ADDENDUM NO. 2

Bid #1449 Temporary Village Phase 5A Project
at
Santa Ana College

January 19, 2024

DSA ADDENDUM NO. 2

A1.0
SITE PLAN

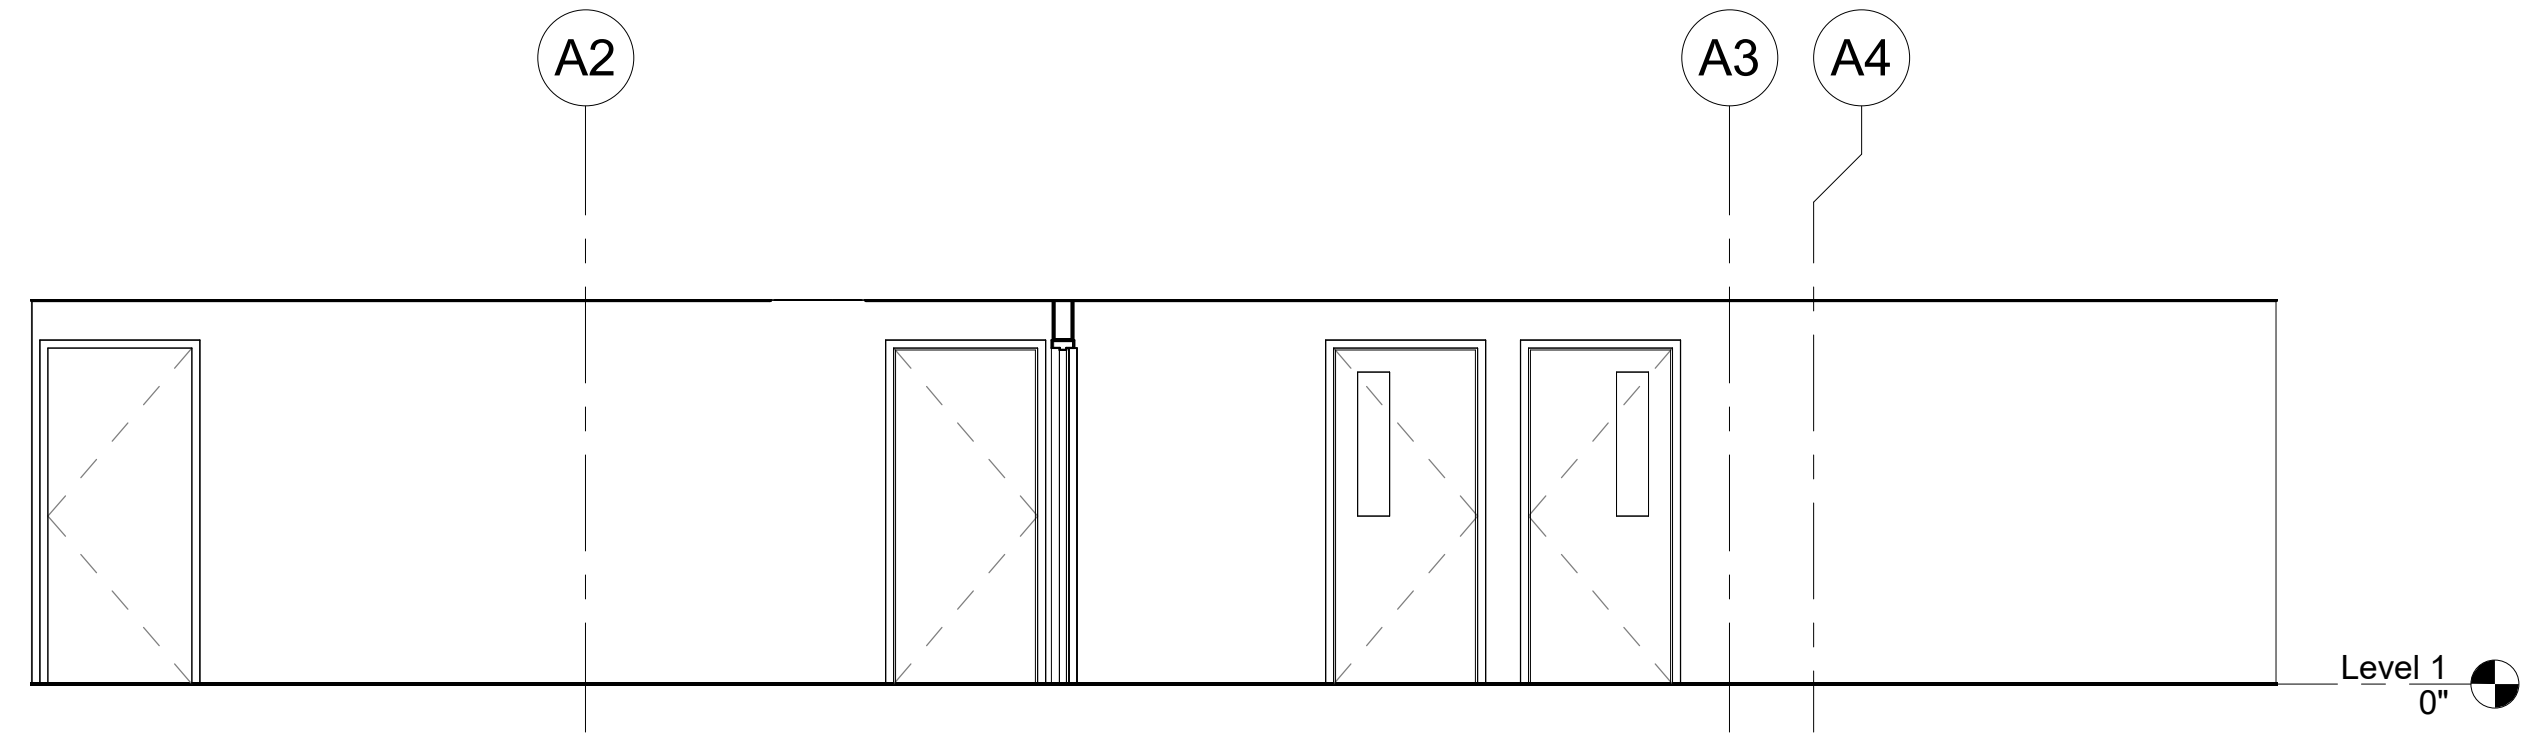
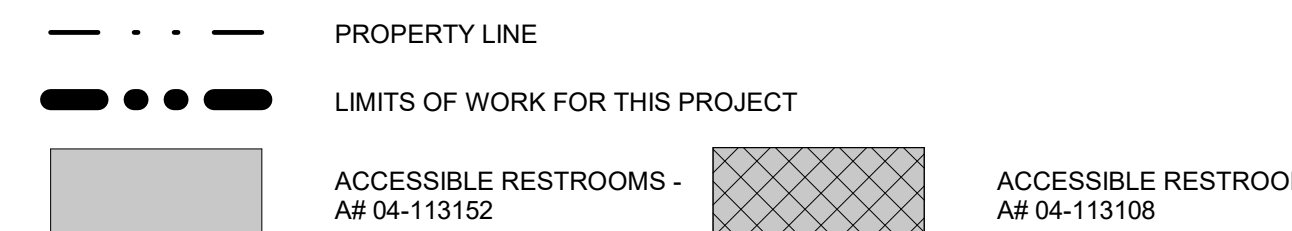
4. Sheet A1.0 – Site Plan

- a. Site Plan Keynotes – Keynotes S2-S3, S9 – S12 and keynotes S-15 – S17 have been updated to reflect that the accessible parking spaces are existing and the indicated detail locations for the spaces are to be referred to as references only.

A40.2
THRIVE CENTER ENLARGED PLANS

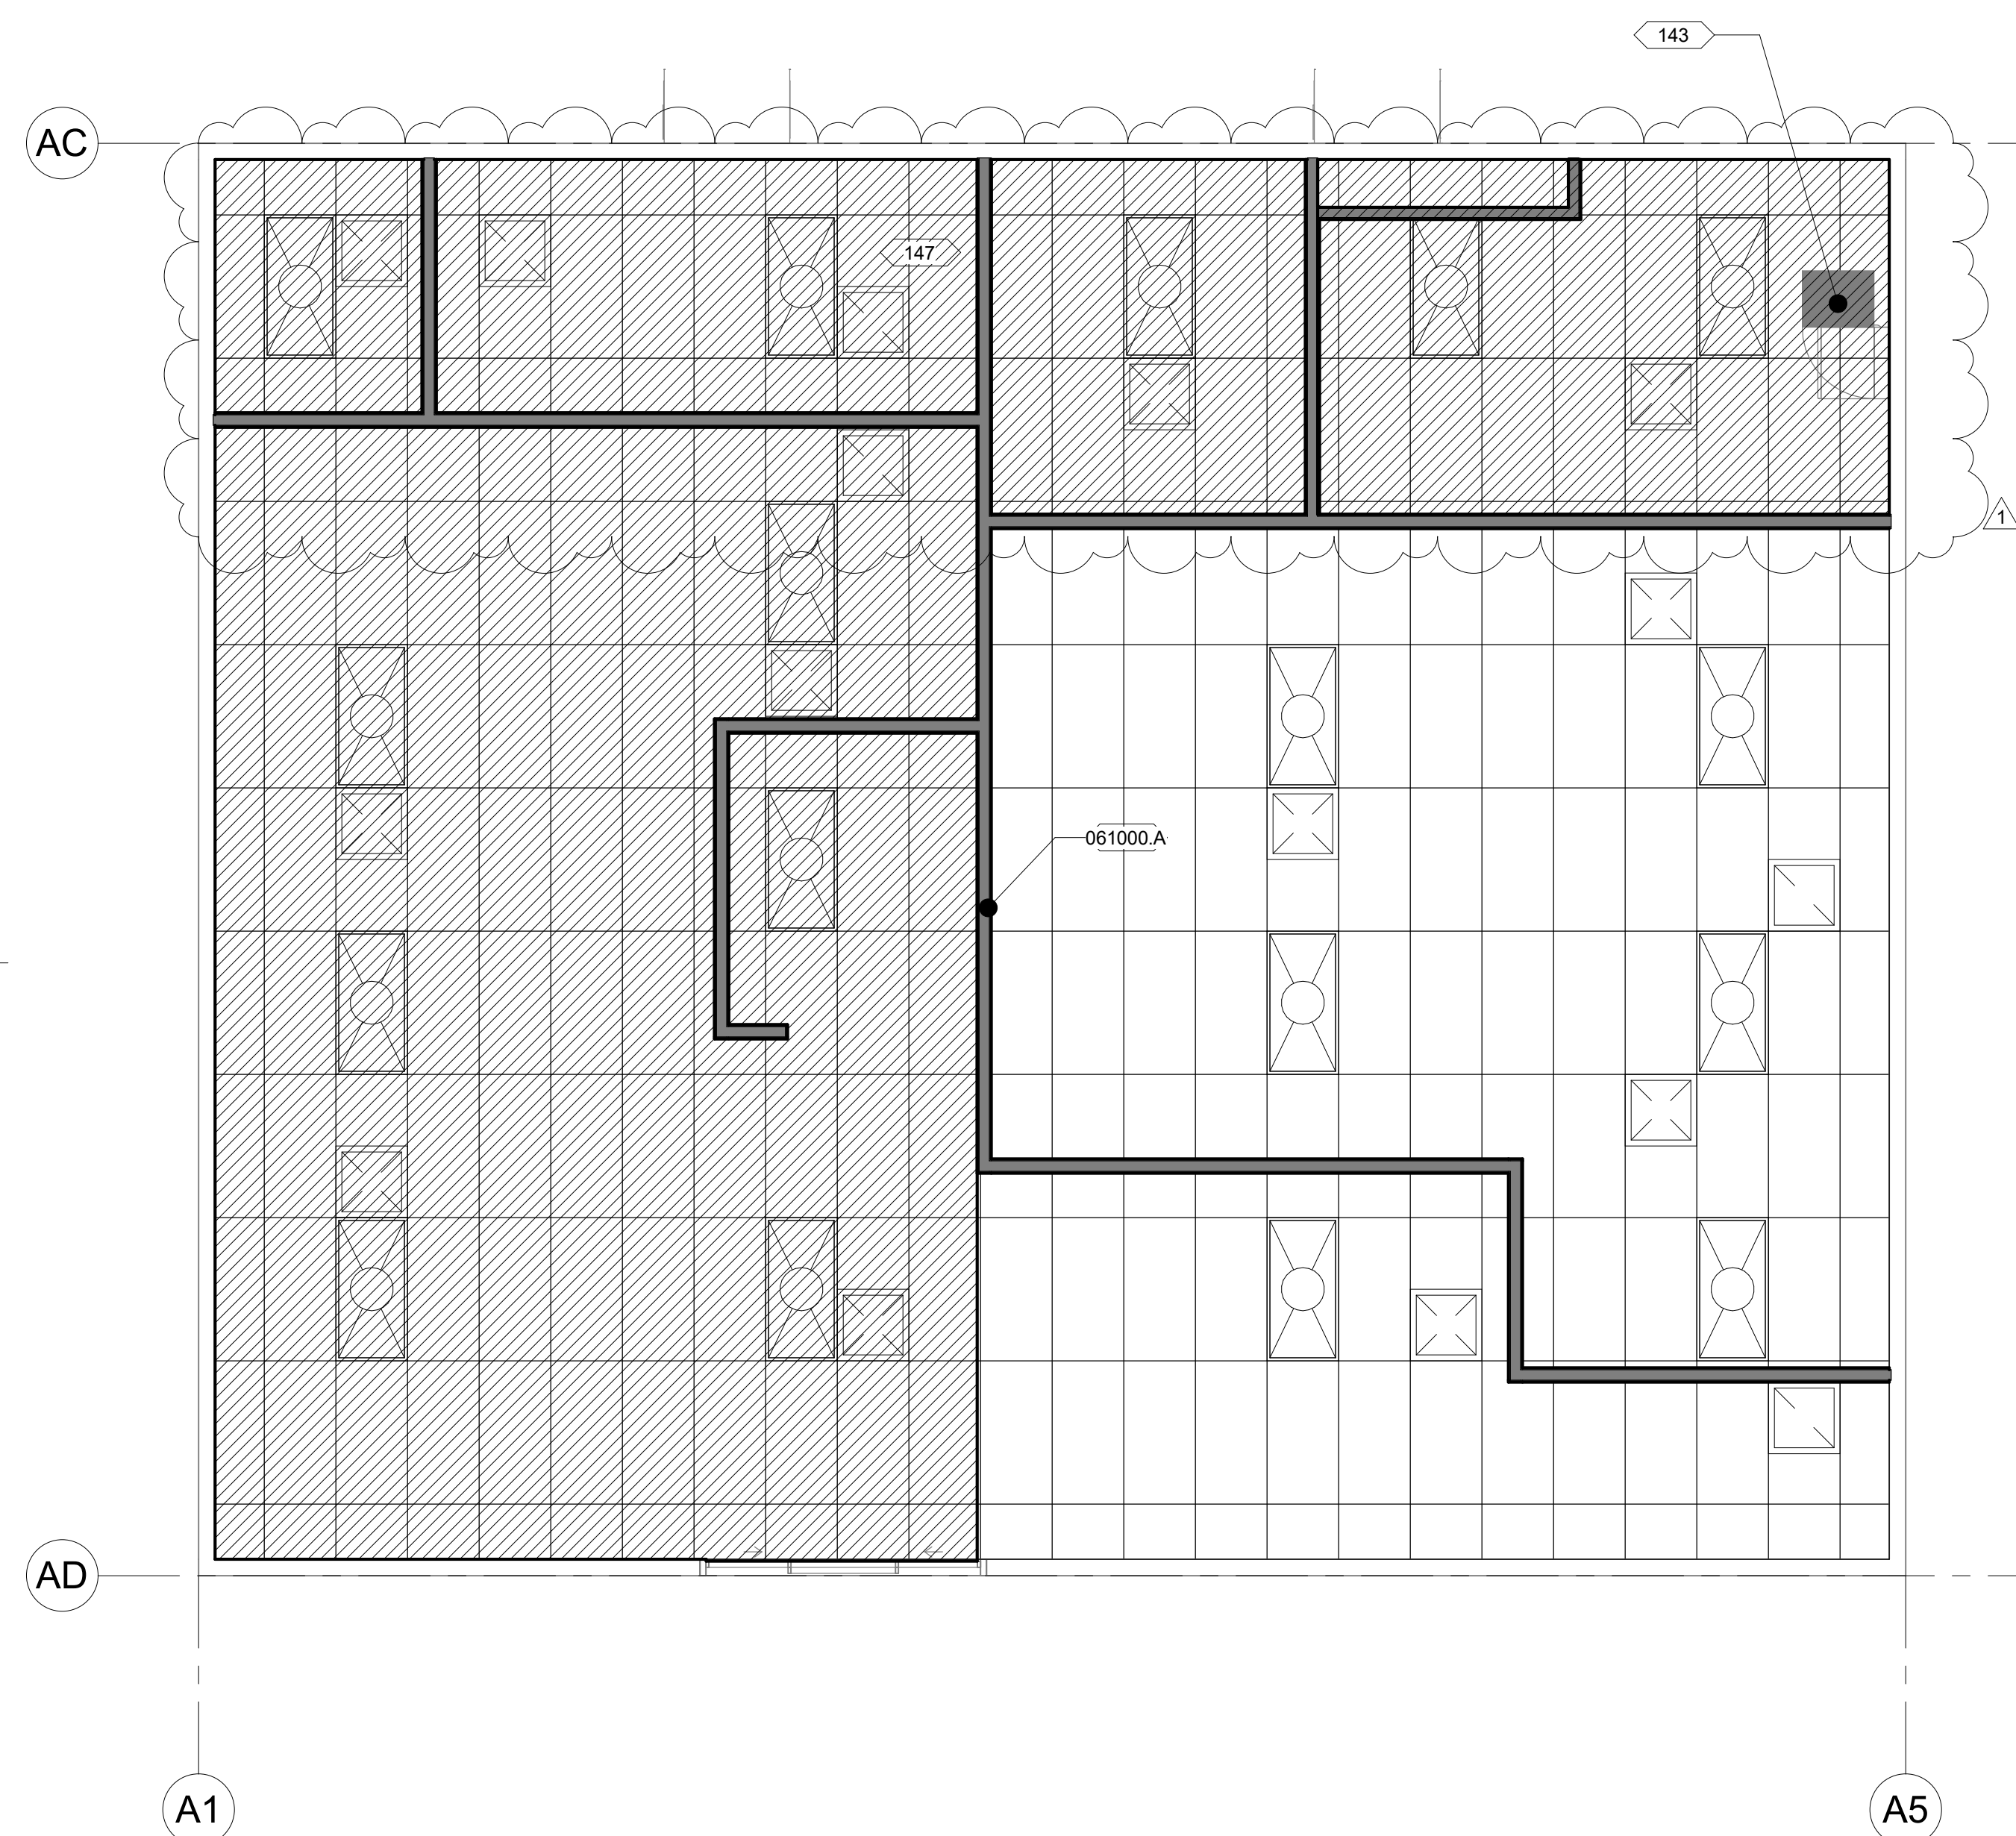
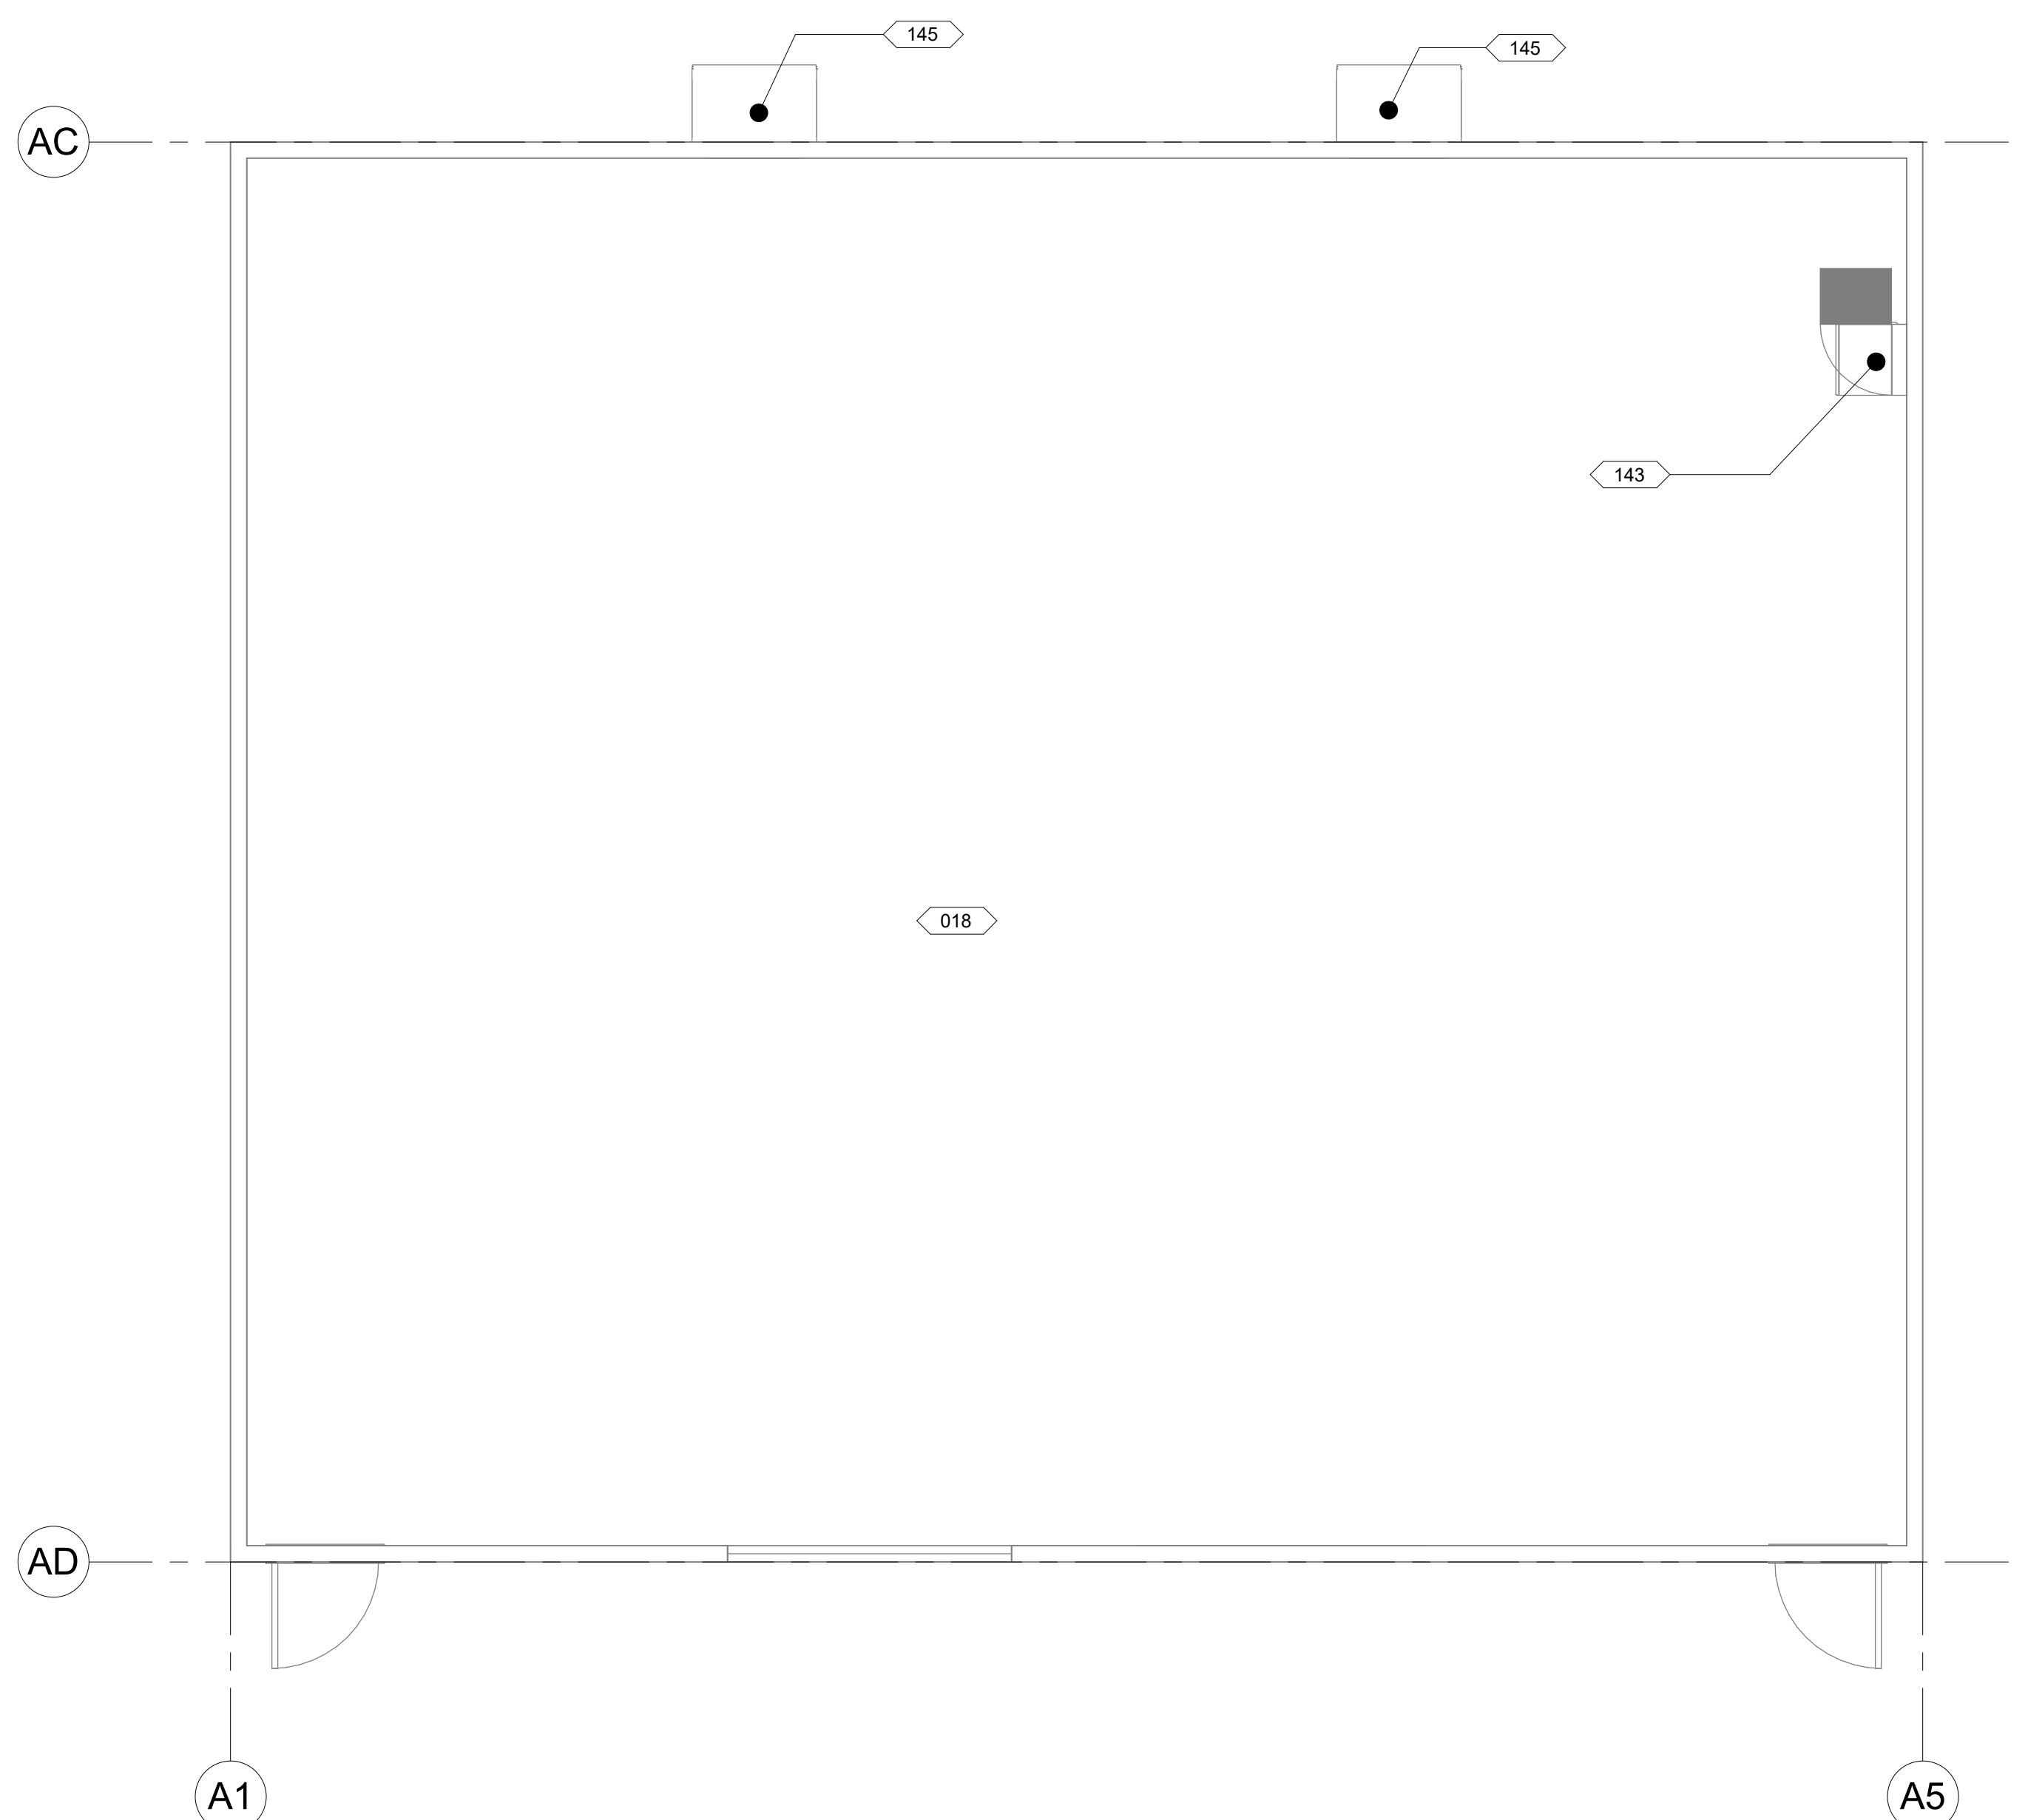
9. Sheet A40.2 – Thrive Center Enlarged Plans
 - a. RCP Legend – Two hatches added to the legend to illustrate in the drawing areas where new suspended ceiling grid extensions are to join ceiling grids and where existing suspended ceiling grids are to be modified per new partition wall installation.
